# 67 Whitfield Street Planning Comments

View from Poets park of 67WS

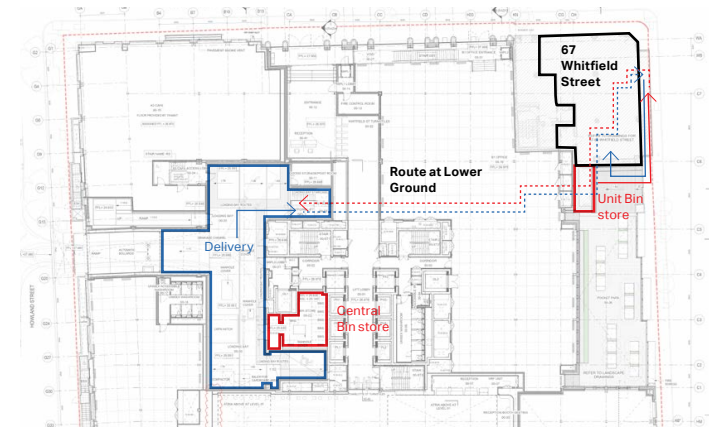
## External seating

The image updated and associated references have been removed in Addendum document ( pg 7, April 2021). Updated image shows space without seating;
